**OBJECTION TO
THE ERECTION OF WIND TURBINES
NEAR HATCH LANE
WESTON**

PLANNING REFERENCE 08/00047/1

**WESTON WIND TURBINE WORKING GROUP
JANUARY 2009**

This document is a submission by the Weston Wind Turbine Working Group to North Hertfordshire District Council objecting to planning application 08/00047/1.

Figure 4-1 Sensitivity analysis – Atmospheric Absorption (House 2)

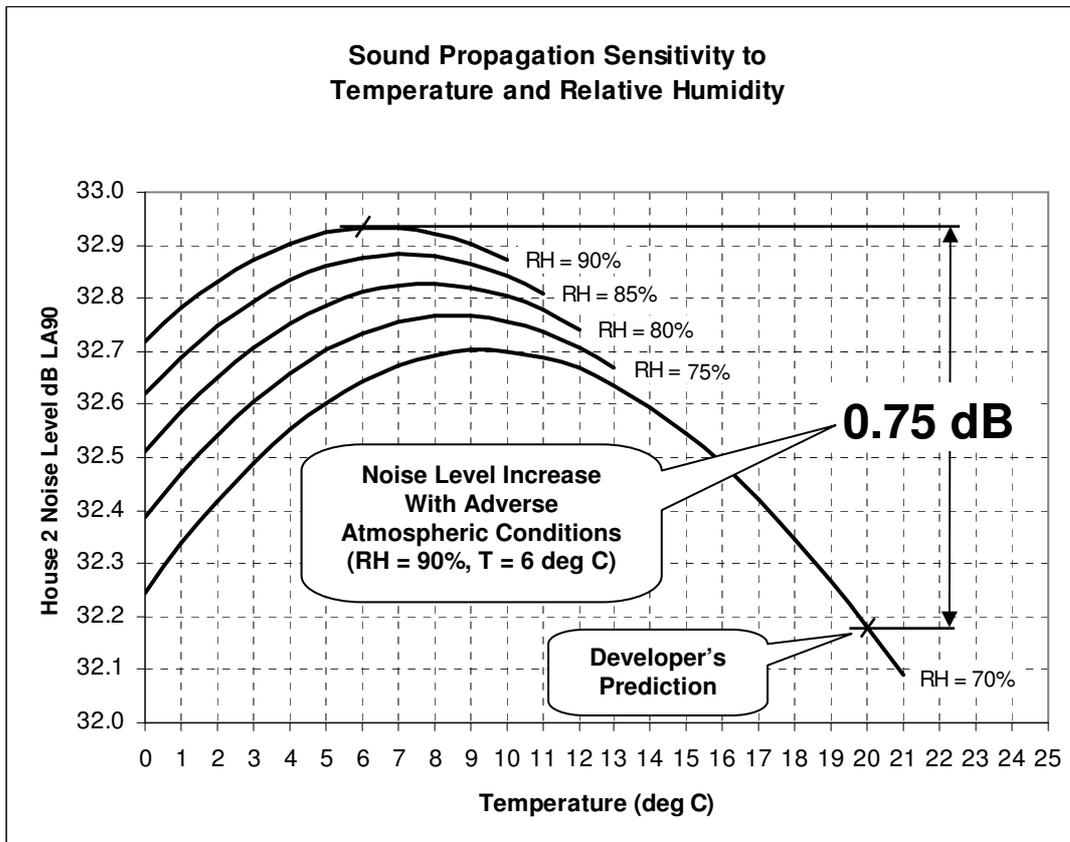
The developer's noise impact assessment fails to consider adverse atmospheric conditions for the calculation of atmospheric attenuation. The report states that the temperature and relative humidity assumed were 20 deg C and 70% respectively. However, the results of the independent sensitivity analysis, shown in Figure 4-1, modelled specifically for the proposed wind farm, demonstrates that when the temperature is 6 deg C and the relative humidity is 90% the noise level at Property 2 would be 0.75dB greater than the value predicted by the developer. (These alternative atmospheric conditions do not represent the absolute worst case, more a typical adverse scenario). This error contributes 0.75dB to the total underestimation of noise predicted for House 2.

Figure 4-2 Sensitivity Analysis – Ground Factor at Receiver (House 2)

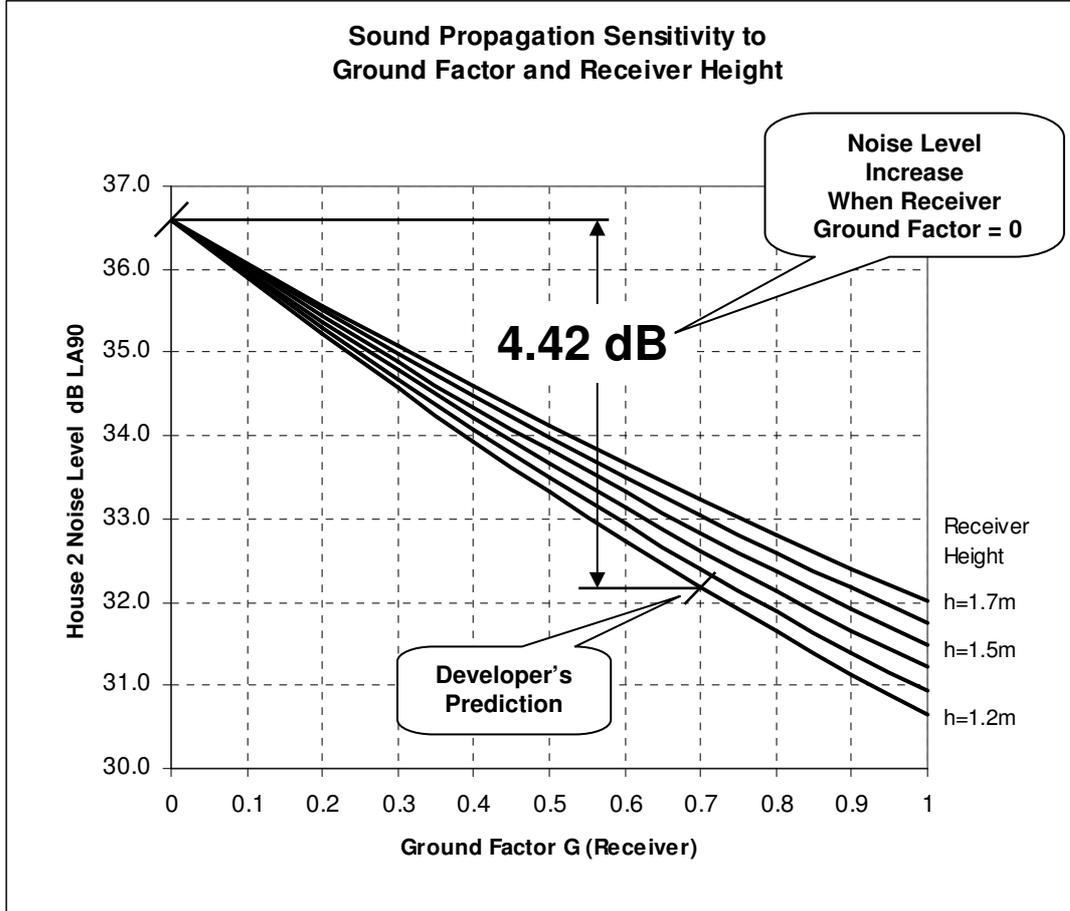
Property 2 would be 4.42dB greater than predicted by the developer. This error therefore contributes 4.42dB to the total underestimation of noise predicted for House 2.

To support this objection, reference is made to a Noise Impact Assessment carried out by the leading UK acoustic consultancy, Hayes McKenzie Partnership where a Ground Factor of 0 was used as worst case (Ref. 4-2).

Figure 4-3 Extract from Vestas V80 Specification Showing Quoted Accuracy of Warranted Noise Output

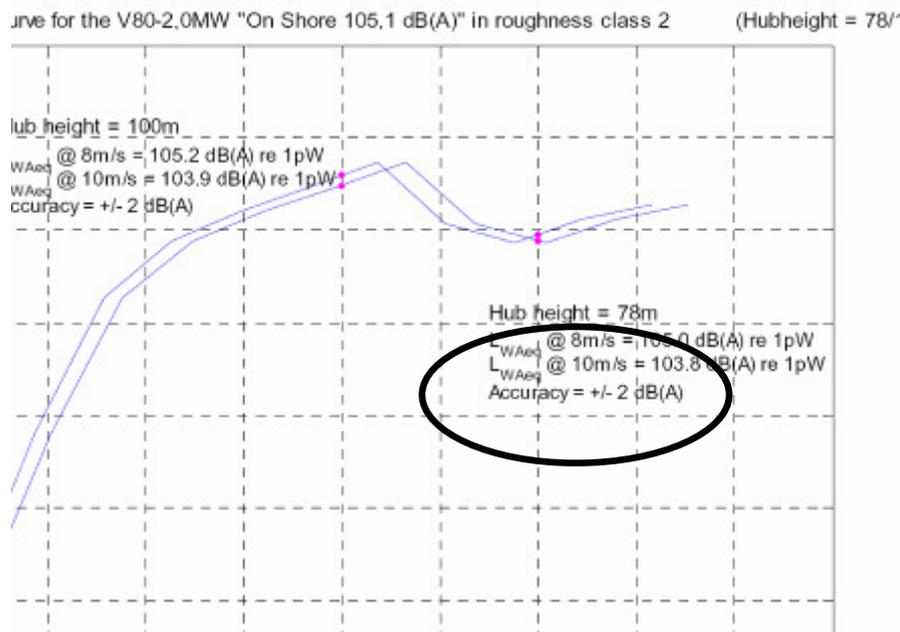
The noise emitted from each wind turbine at source provides the starting point in any wind farm noise propagation calculation. Turbine noise emission levels are measured during the turbine's design and certification phase and are then used by acoustic consultants to predict noise levels around individual wind farms. Like any measurement made in a scientific environment, some degree of inaccuracy will exist. It is normal practice for a manufacturer to warrant accuracy levels applicable to a product's performance within the 'product specification'. Indeed, within the Vestas V80 specification 944406.13 (Ref. 4-4) the turbine sound power level at source has an accuracy of +/- 2dB(A), as indicated in the extract shown in Figure 4-3.

It is 'good practice' in any scientific analysis to consider accuracy levels in order to establish the best and worst possible outcomes. The Noise Impact Assessment must be conducted in a way that provides the community, the developer and the approving authority with confidence that the wind farm design is actually capable of meeting the noise limits set out in ETSU-R-97. The worst case inaccuracy must therefore be assumed.

Figure 4-4 Developer's Photograph Showing Microphone Positions at House 2

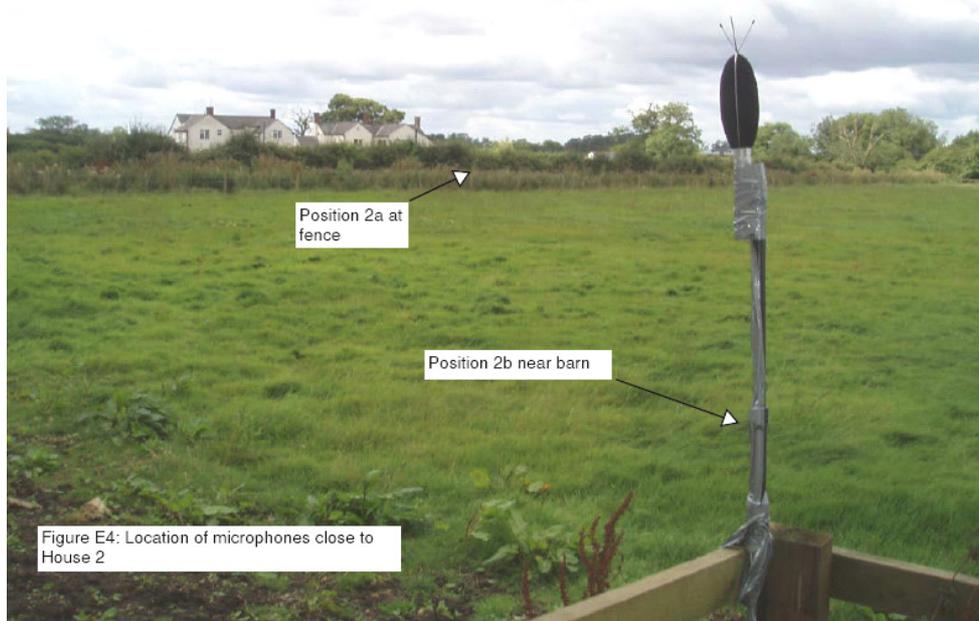
The Noise Impact Assessment provides details of the microphone positions at House 2 and includes a photograph as evidence. This photograph is reproduced in Figure 4-4.

At 'House 2' there was ample scope for the developer to position the microphone close to the property, either in the rear garden or the adjacent field. Surprisingly, the microphone was initially located at position '2a', a distance of approximately 80m from 'House 2'. It was then moved to a second position, '2b', approximately 150m from the property to, as the report describes, 'assess the effect of insect noise in nearby long grass on

background measurements during the day'. Measurement of insect noises was a blatant attempt to artificially increase the sound levels and distort the background noise survey in favour of the development.

Figure 4-5 Aerial View Showing Microphone Positions at House 2

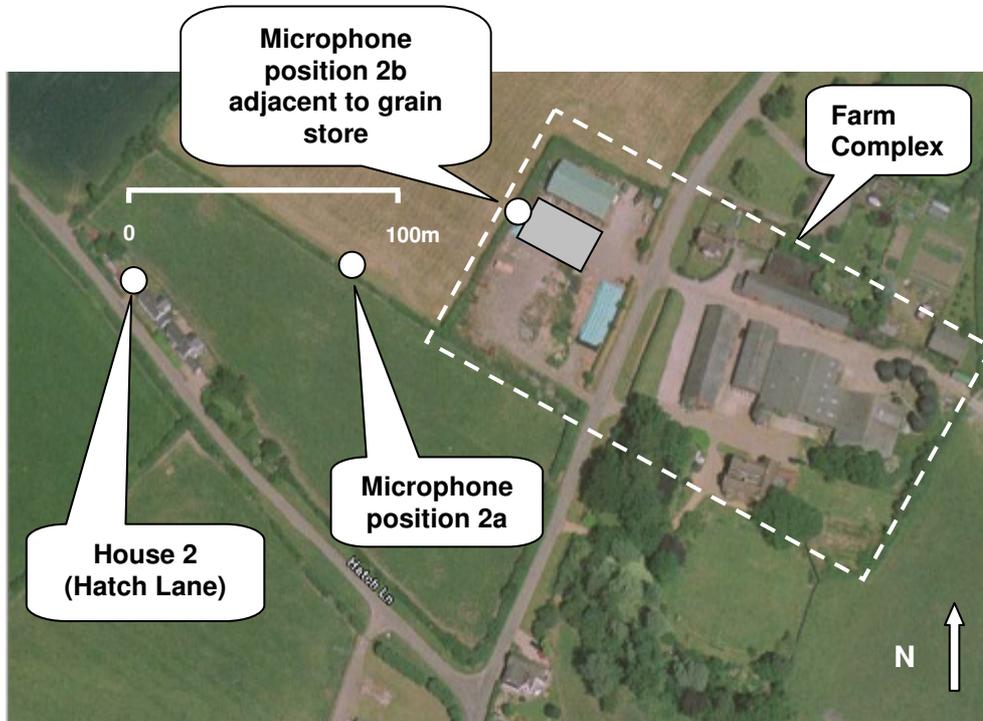
Figure 4-5 shows the position of the microphones marked on an aerial photograph, which clearly demonstrates that there was no attempt to locate them near to House 2

Both microphone positions were located near to the developer's farm complex at Darnall's Hall. This means that extraneous noises from farm machinery would have been recorded and if these were not short duration they may have been included within the $L_{A90,10min}$ background readings. This alone is enough to cast serious doubt over the validity of the background noise readings at House 2.

Figure 4-8 Developer’s Daytime Background Noise Plot for House 2 (Annotated)

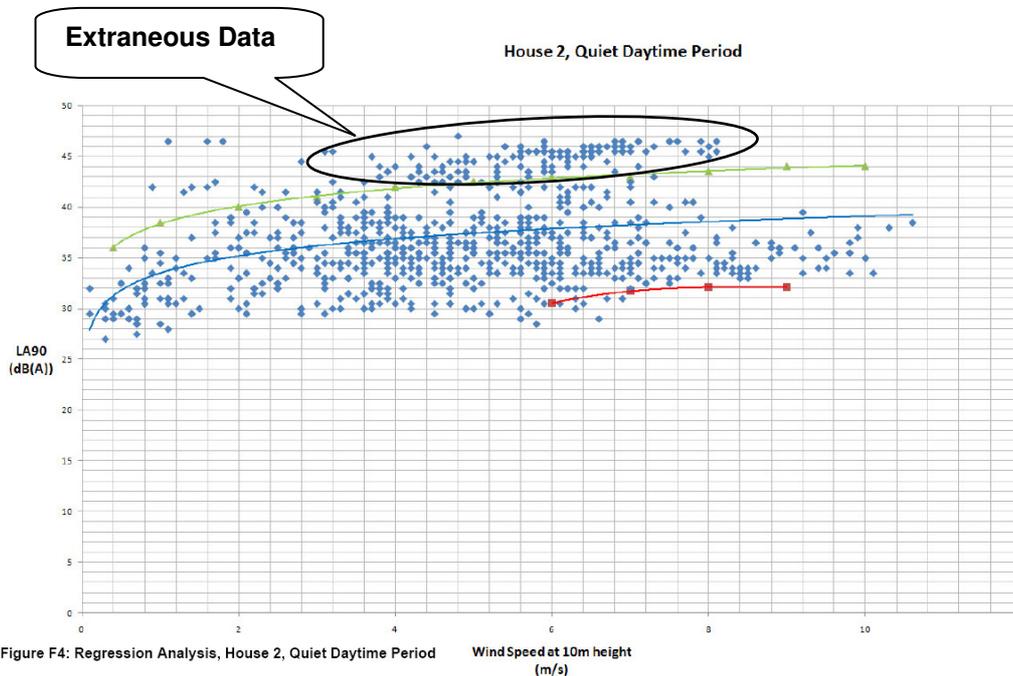
The data points plotted by the acoustic consultant for the background noise survey at House 2 (Quiet Daytime Period) are shown in Figure 4-8 .

An area of extraneous data with particularly high noise level, in the region of 45 dB, is shown highlighted. There is no explanation given in the Noise Impact Assessment as to the source of this extraneous data. This data is too distinct from main data to be ignored. It is possible this could be atypical noise resulting from the operation of farm machinery nearby, operation of the grain store adjacent to microphone 2b or the noise from rainfall hitting the ground, grain store or microphone.

Figure 5-1 Mandated Flight Path in Relation to Wind Farm Exclusion Zone

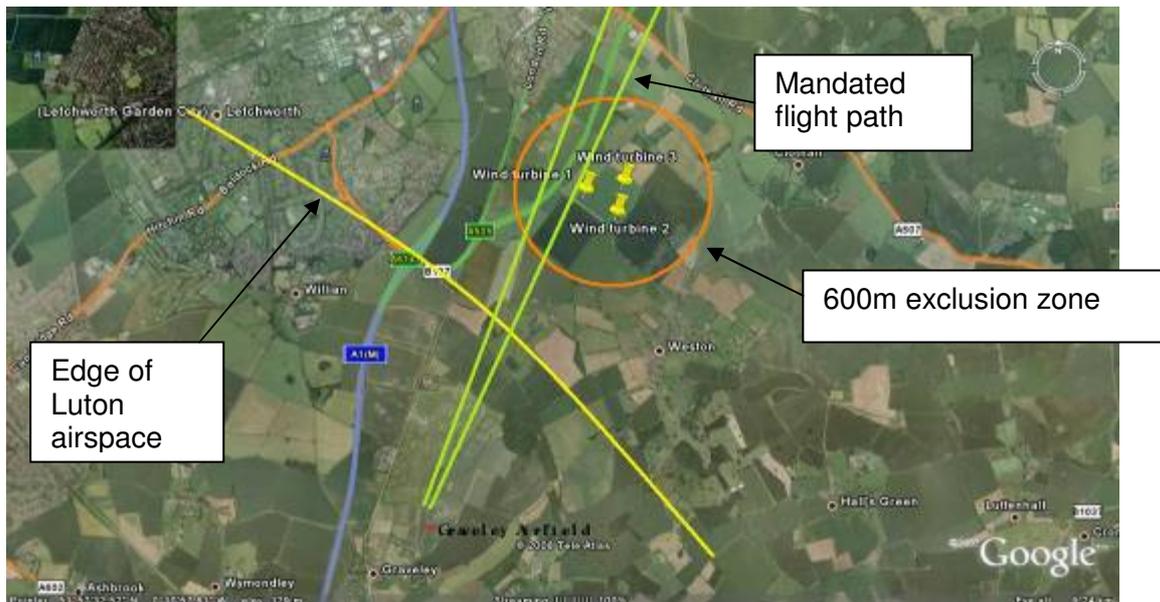
Graveley airfield is situated 7 nautical miles north east of Luton Airport at 330 feet Above Sea Level (ASL) and has approximately 1500 aircraft movements per annum. The airfield is inside Luton Control Zone (CTR) and therefore has to operate under a letter of agreement between the airfield operator and National Air Traffic Services (NATS). This agreement requires aircraft approaching or departing from Graveley to remain below 1000 ft ASL and mandates that exit/entry of the zone is to the north as depicted by the green lines in Figure 5-1.

The nature of the development would constitute a "congested zone" under rule 5 of the Air Navigation Order and therefore pilots would need to avoid the site by 1000 feet vertically and 600m horizontally as depicted by the orange line in Figure 5-1. This effectively closes off the existing mandated flight path for Graveley airfield.
